Technical Service Bulletin: TSB180071

Fuel Pump Low Pressure Fuel Supply Tube Malfunction

Figure 1, Location of Air Bleed Orifice Screen in Fuel Pump Actuator Adapter Housing Removed from High Pressure Fuel Pump.

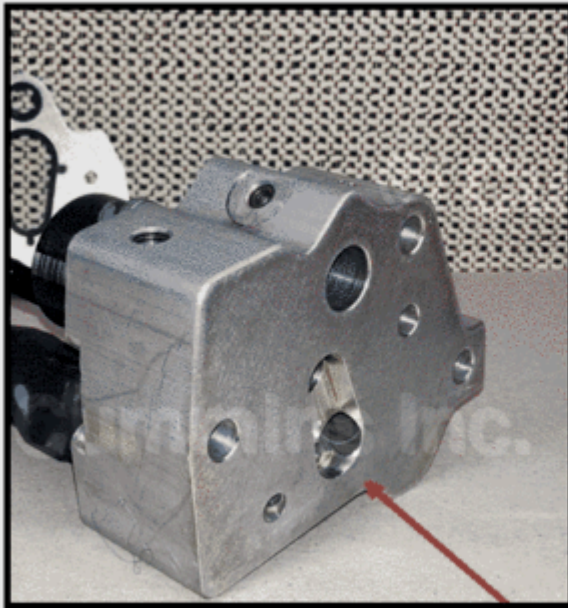
- Fuel pump actuator housing air bleed screen contaminated with debris.
- Debris accumulation prevents fuel flow to drain. Low-pressure fuel system temperature increases. See Figure 1 below.

Figure 3, Location of Fuel Supply Tube Malfunction.

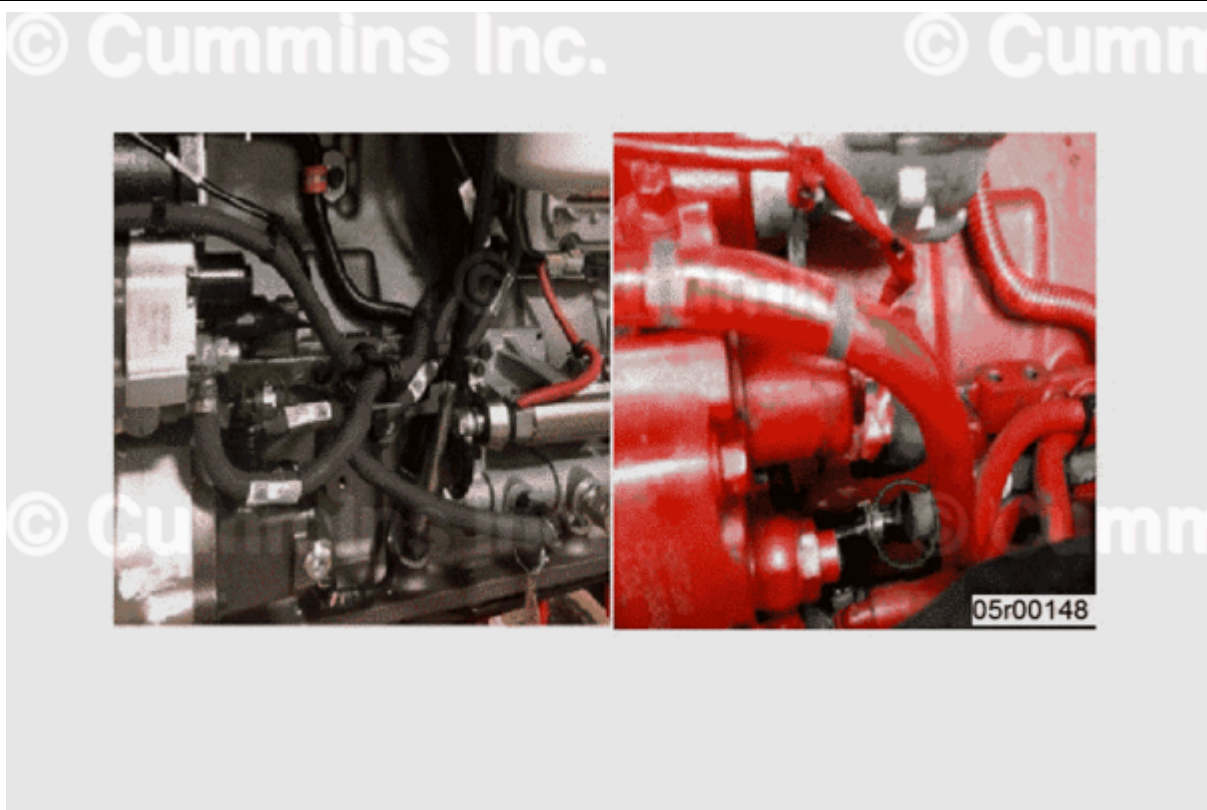
If damage to low pressure fuel supply tube is found:

- Identify fuel supply tube configuration installed. See Steel Fuel Supply Tube Installation Instructions 5414654.
- Replace malfunctioning low pressure fuel supply tube with newly released steel fuel supply tube. See Steel Fuel Supply Tube Installation Instructions 5414654.
- Identify plugging in fuel pump actuator housing. Perform the High-Pressure Fuel Pump Return Flow Test. See corresponding Service Manual. Reference Procedure 005-236 in Section 5.
- If fuel pump return flow collected is less than 150 ml/cc in 30 seconds, the fuel pump actuator housing and fuel pump actuator has malfunctioned and **must** be replaced.
